UNTIL SUCH TIME AS THESE DRAWINGS ARE APPROVED BY THE APPROPRIATE REVIEWING AGENCIES, JR ENGINEERING ACCEPTS NO LIABILITY ONLY FOR THE PURPOSES DESIGNATED BY WRITTEN AUTHORIZATION.	
PREPARED FOR	SR LAND, LLC 20 BOULDER CRESCENT SUITE 201 COLORADO SPRINGS, CO 80903 JAMES F. MORLEY (719) 471-1742
	 J-R ENGINEERING A Western Company Centennial 303-740-9883 • Colorado Springs 719-589-2588 Fort Collins 970-491-9888 • www.jrengineering.com
BY	DATE
No.	REVISION
H-SCALE 1"=60'	N/A
V-SCALE	DATE 05/09/23
DESIGNED BY	RAB
DRAWN BY	CGV
CHECKED BY	
STERLING RANCH ROAD & BRIARGATE PARKWAY SEGMENT 2 GESC	
GRADING AND EROSION CONTROL PLANS	
SHEET 4	OF 9
JOB NO.	25188.03

STERLING RANCH ROAD & BRIARGATE PARKWAY SEGMENT 2 GESC
DETAIL SHEETS

v5_GEC.pdf Markup Summary

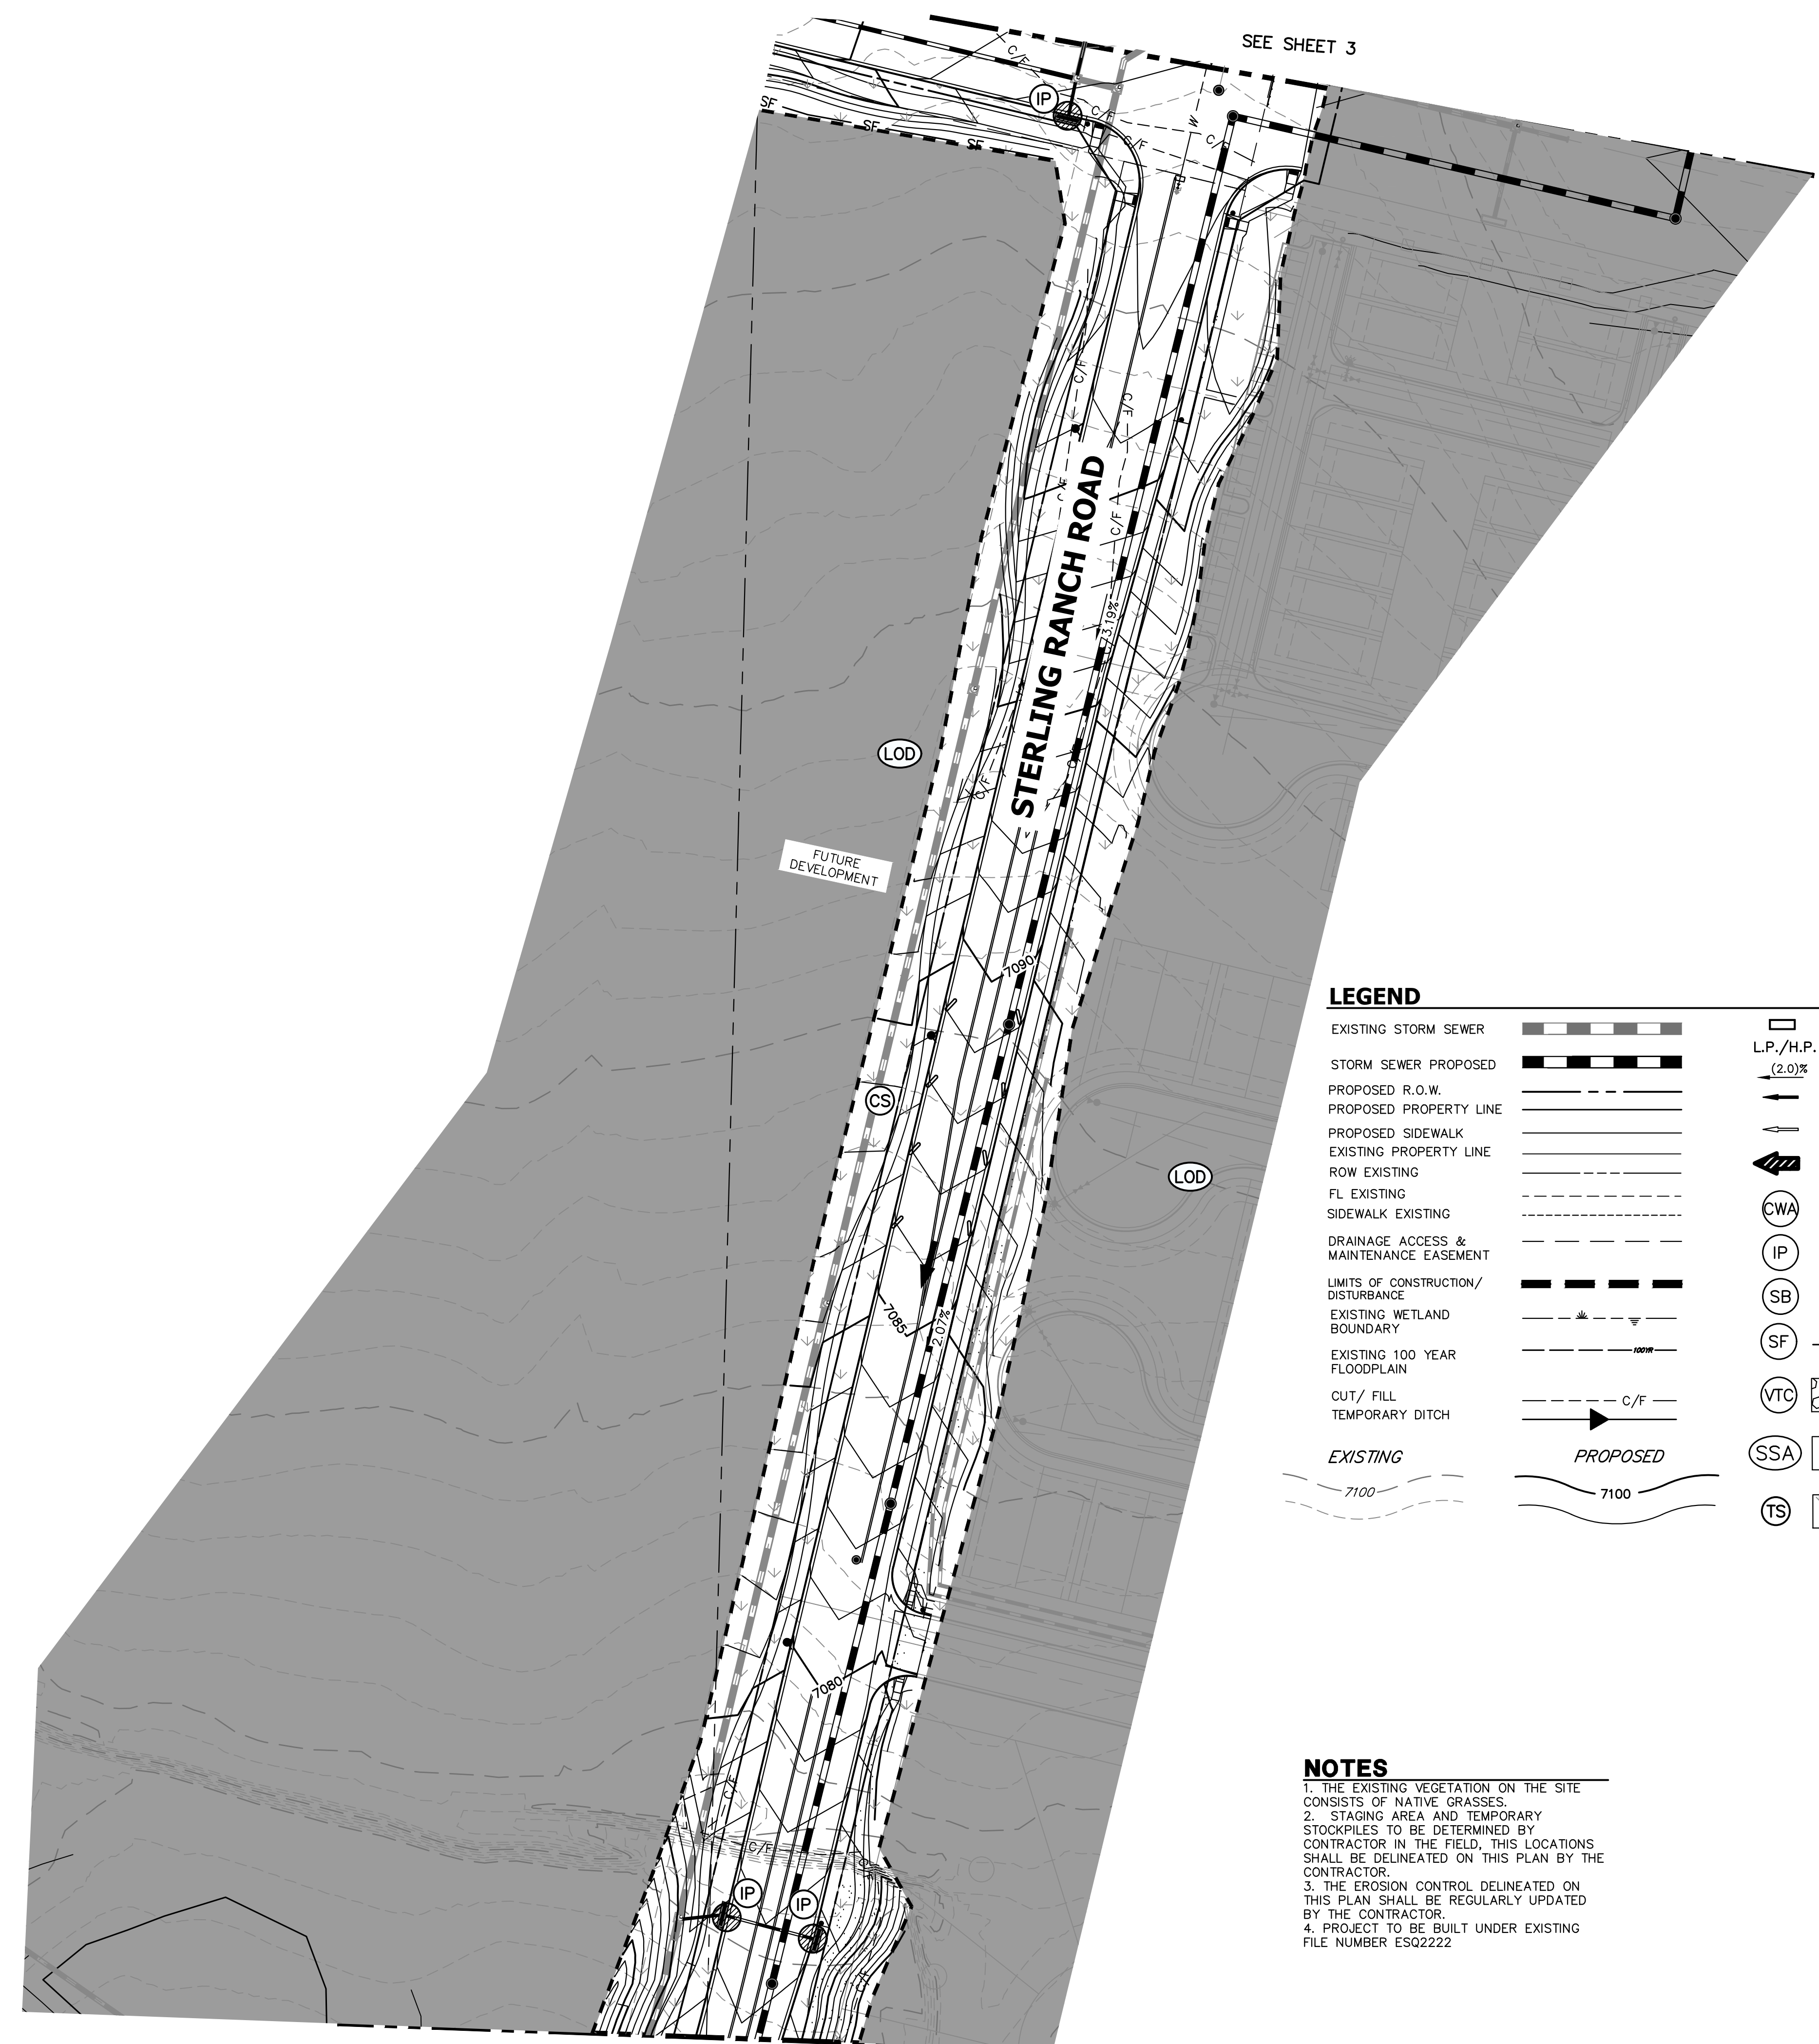
Why no TSB shown here anymore? Runoff from areas >1ac need to be conveyed to a TSB for treatment during construction (before and after installation of SW piping and inlets).

Subject: SW - Textbox
Page Label: [2] GR_01 SRR and BGP-GESC (1)
Author: Glenn Reese - EPC Stormwater
Date: 5/31/2023 10:30:34 AM
Status:
Color: ■ JR RESPONSE: "GRAY"
Layer: GRADING AND POND ARE SHOWN FOR FUTURE CONDITION NO BGP
Space: SR RD FLOWS DRAIN TO POND 16

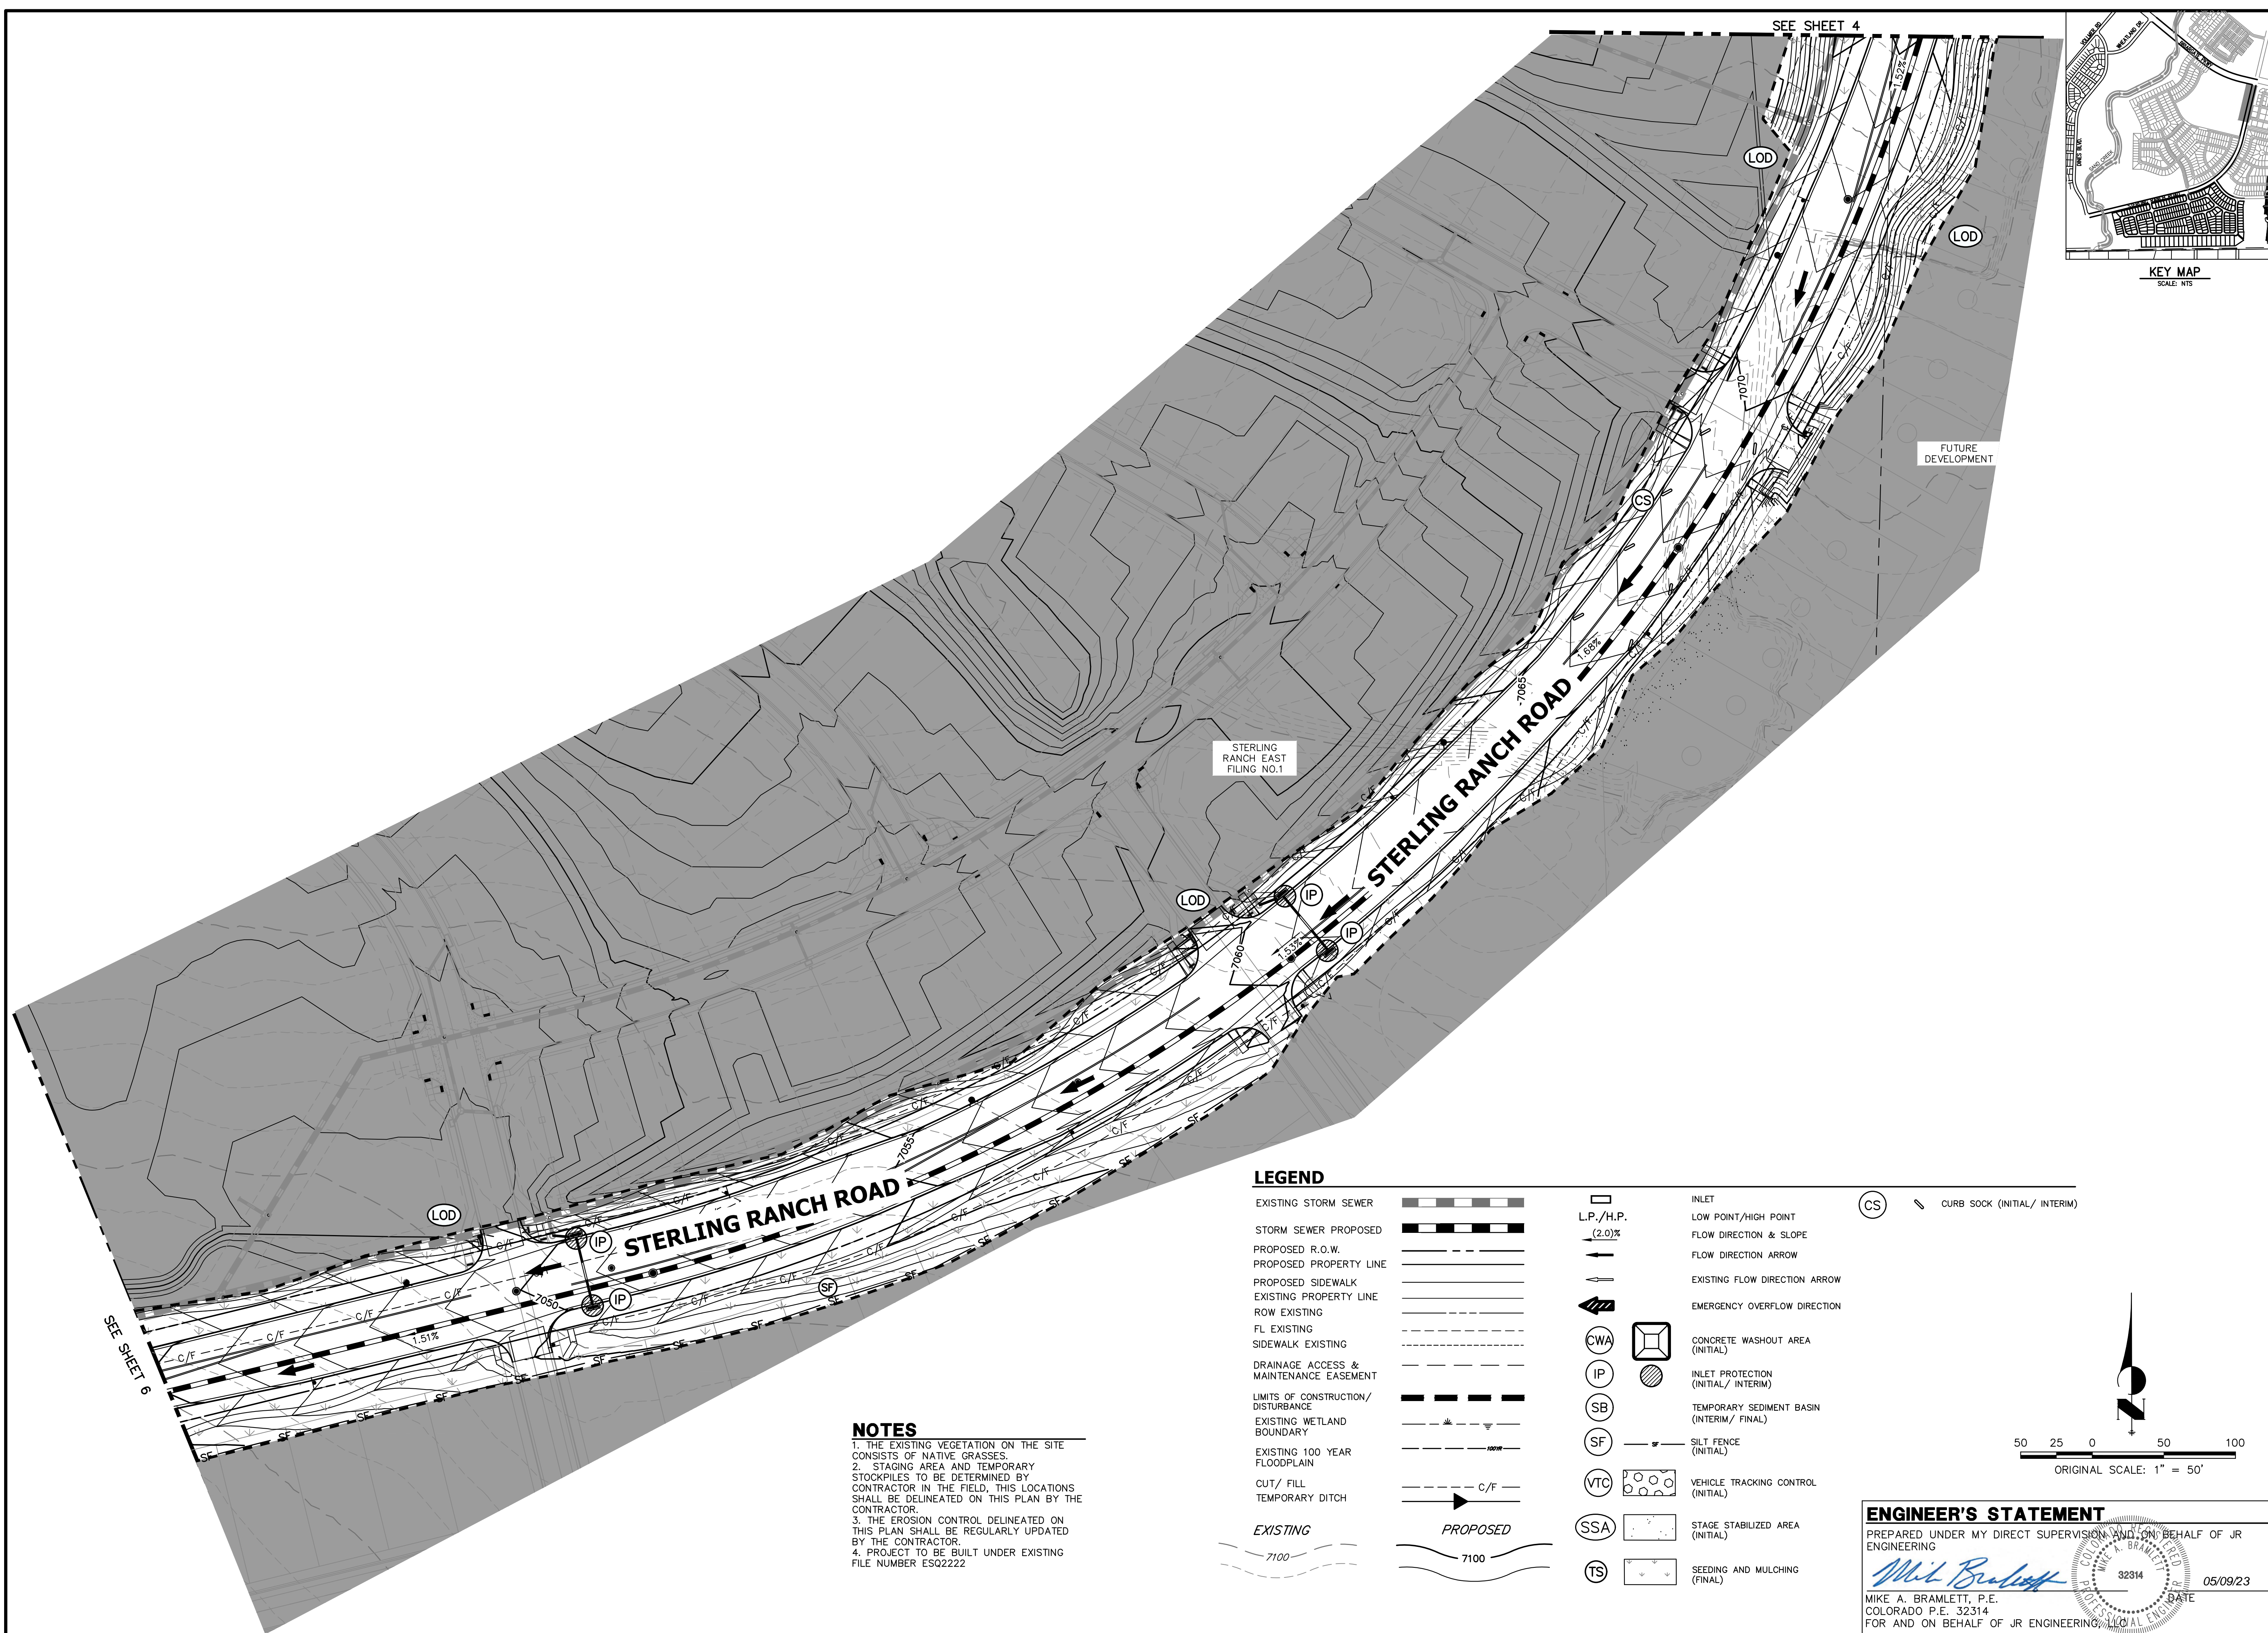
Provide a detail for forebay if to be constructed with this ESQCP.

Per drainage maps in FDR, most of the proposed grading is tributary to this pond, so a TSB should be shown here (as either proposed or existing).

Subject: SW - Textbox with Arrow
Page Label: [5] GR_01 SRR and BGP-GESC (4)
Author: Glenn Reese - EPC Stormwater
Date: 5/31/2023 10:44:26 AM
Status:
Color: ■ JR RESPONSE: DETAIL ADDED
Layer:
Space:

Subject: SW - Textbox
Page Label: [5] GR_01 SRR and BGP-GESC (4)
Author: Glenn Reese - EPC Stormwater
Date: 5/31/2023 5:18:01 PM
Status:
Color: ■ JR RESPONSE: NOTE HAS BEEN ADDED TO PLANS TO CLARIFY SEQUENCE OF CONSTRUCTION
Layer:
Space:
